**NOIDA METRO RAIL CORPORATION LTD.**

**Part Design & Construction of Elevated Viaduct and 10 nos. of Elevated Stations for Extension Projects of NMRC's Aqua Line from Botanical Garden to Noida Sec-142 (from Chainage (-) 383.959 to 12130.143) and from Depot Station to Boraki MMTH (Chainage 28678.253 to 31263.482).**

**E-Tender no. - NMRC/Projects/NGNECC/2026/457**

**ADDENDUM-2  
SUMMARY SHEET**

VIADUCT  
DRAWING TITLE: GENERAL ARRANGEMENT DRAWING PLAN AND PROFILE FROM CH DN LINE: -380m TO CH: 340m

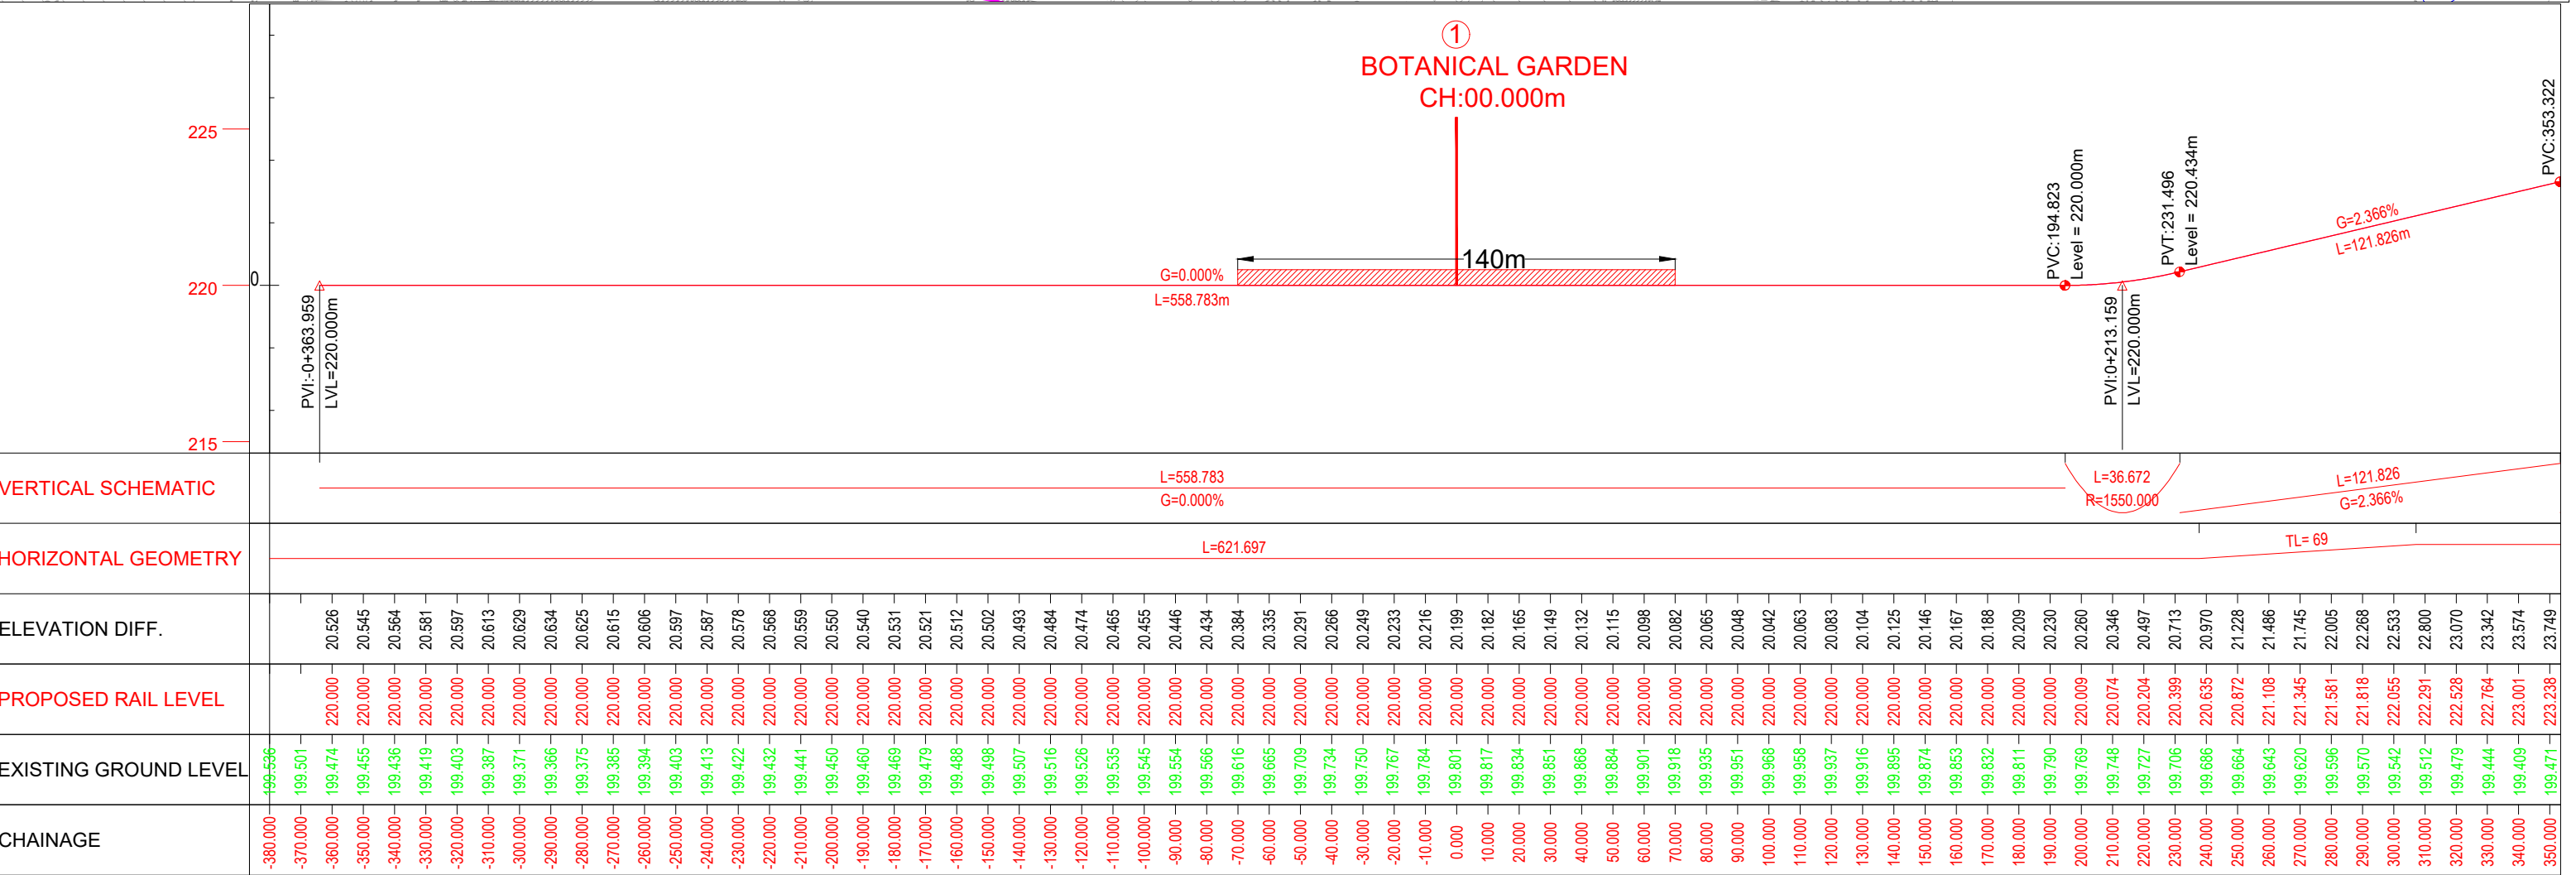
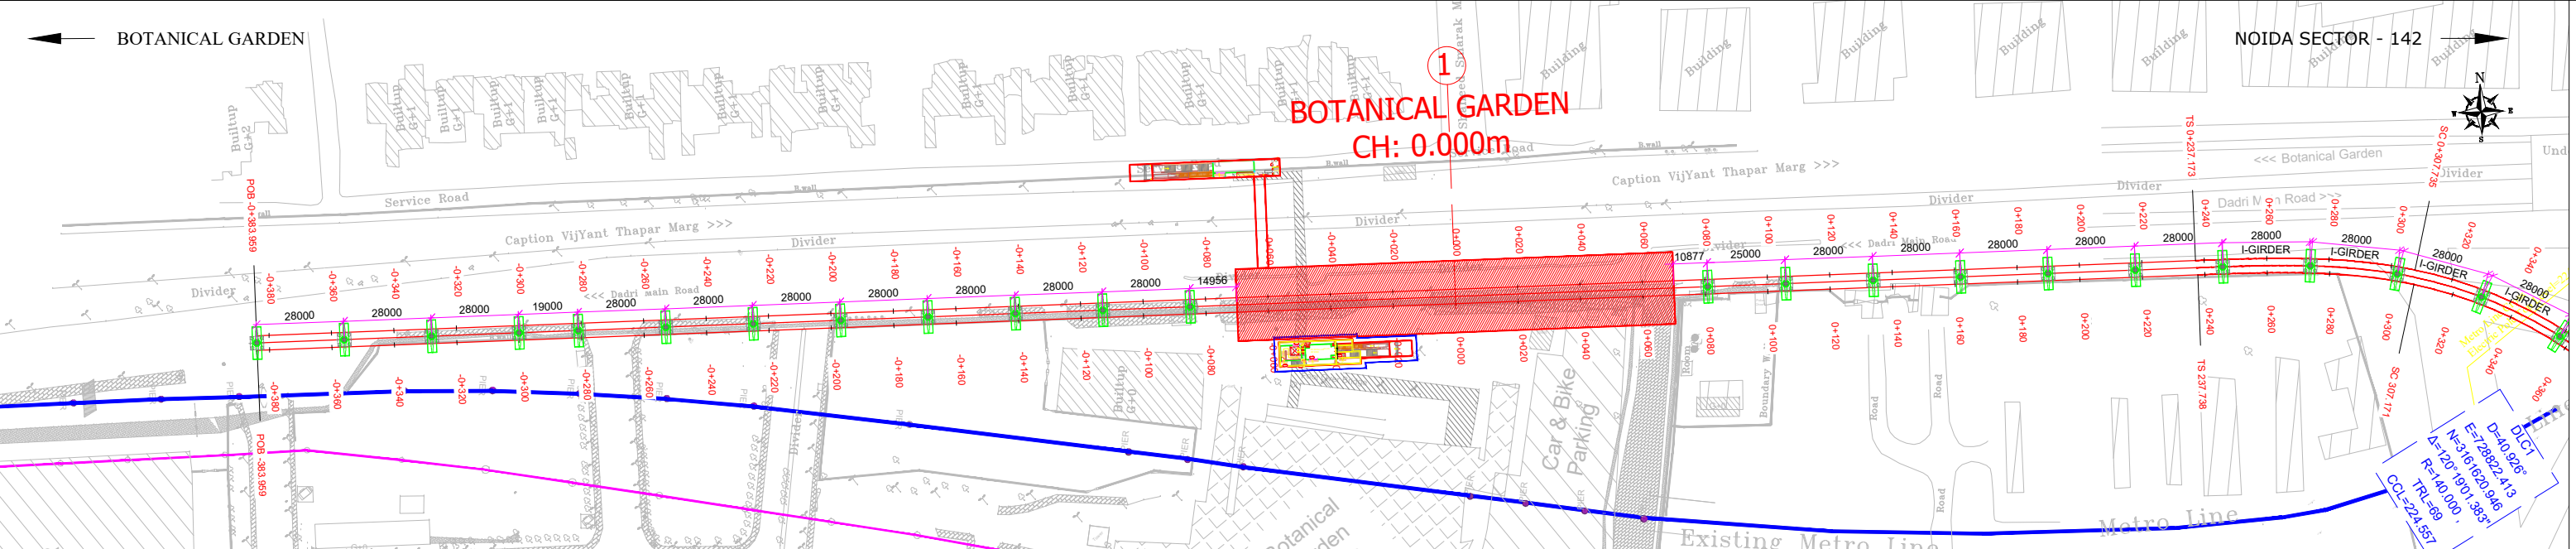
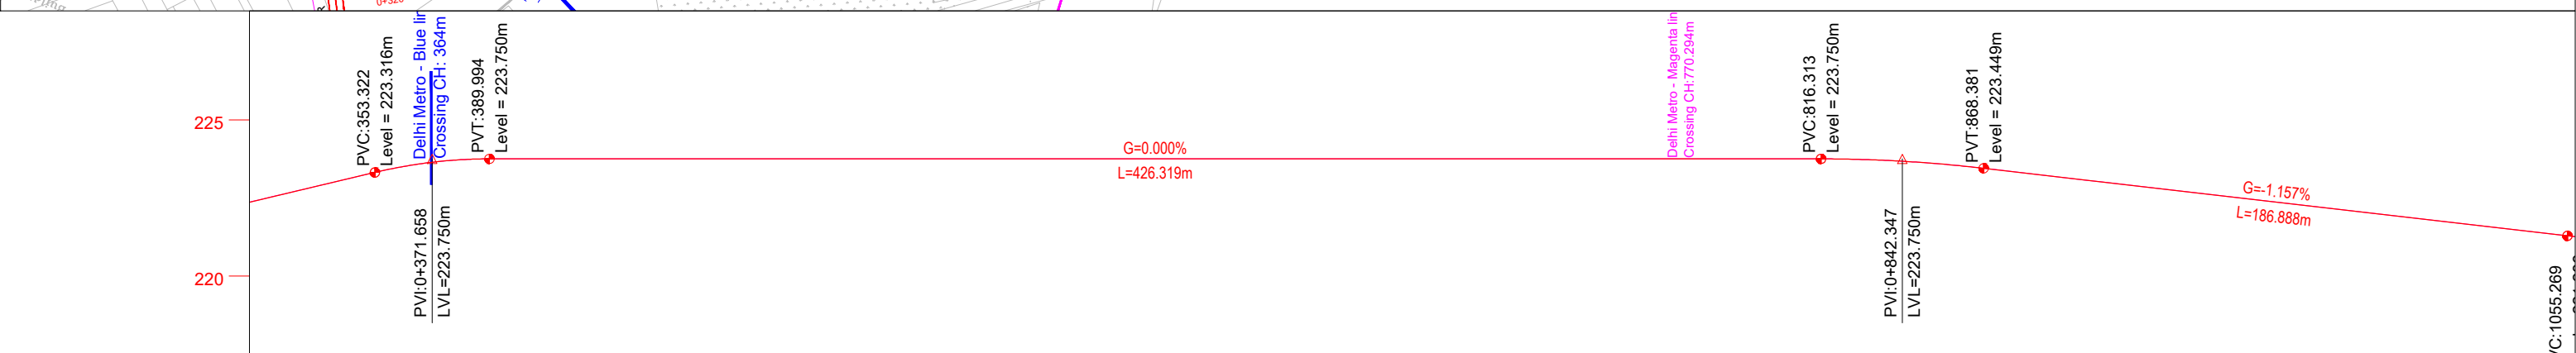
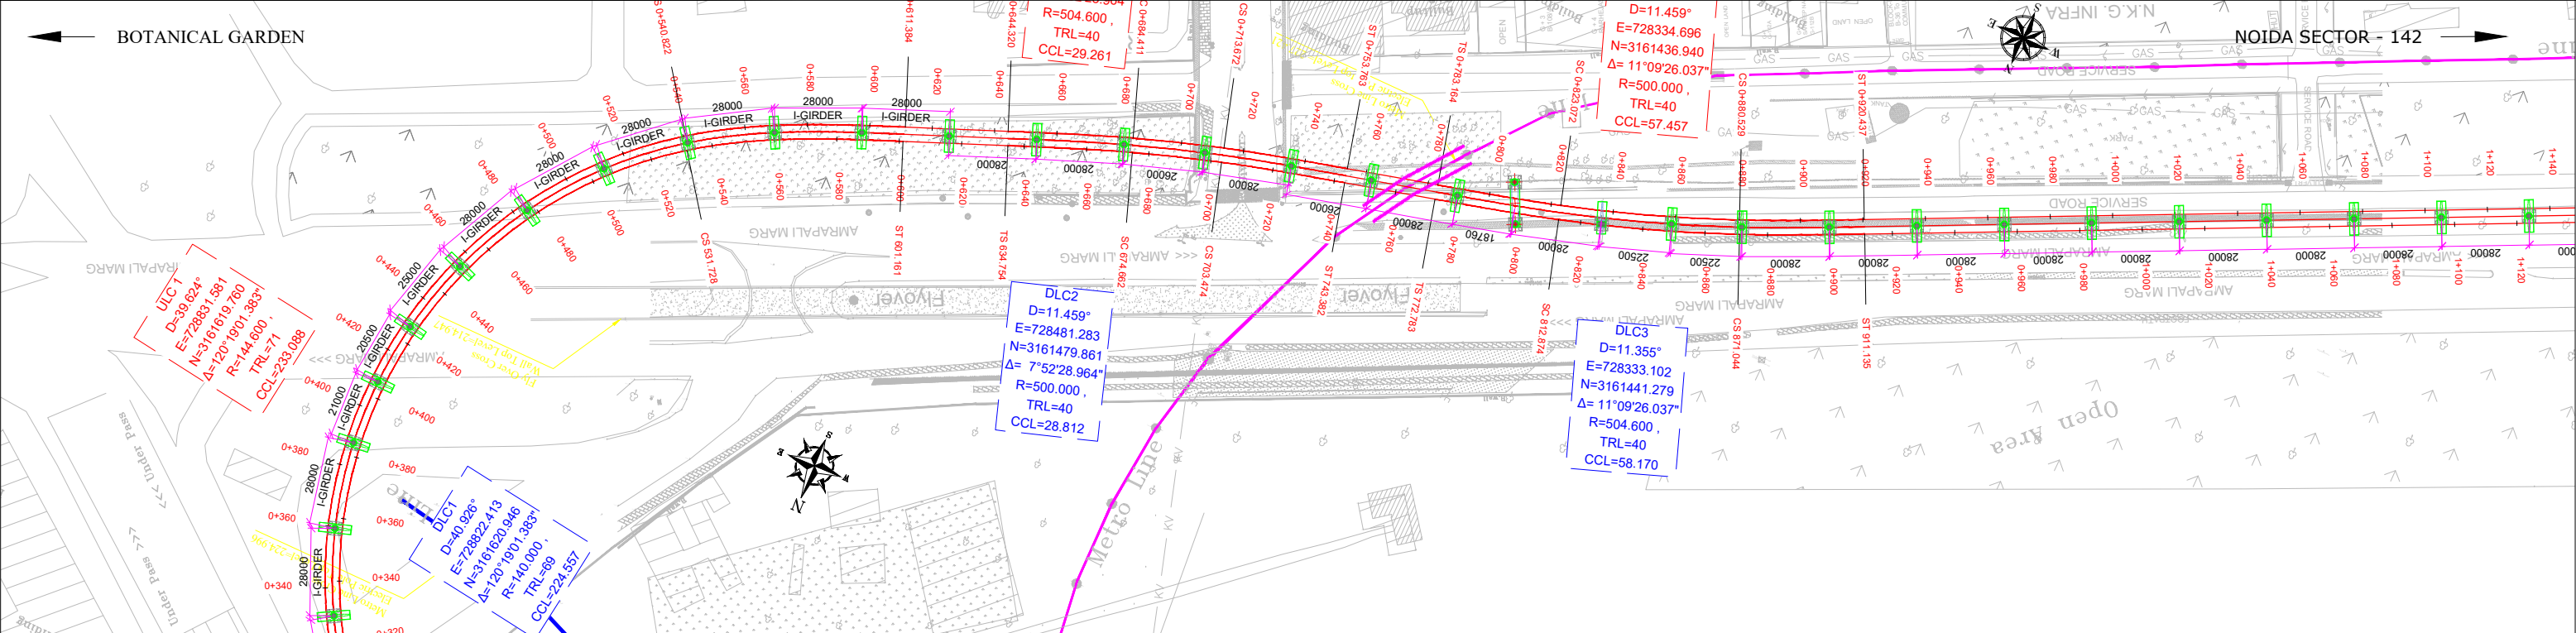
REV.	DESCRIPTION	DATE	DRAWN BY	CHECKED BY
R0	INITIAL DRAWING	20.04.2026	PB	D.S
R1	G.L. MODIFIED	01.06.2026	PB	D.S
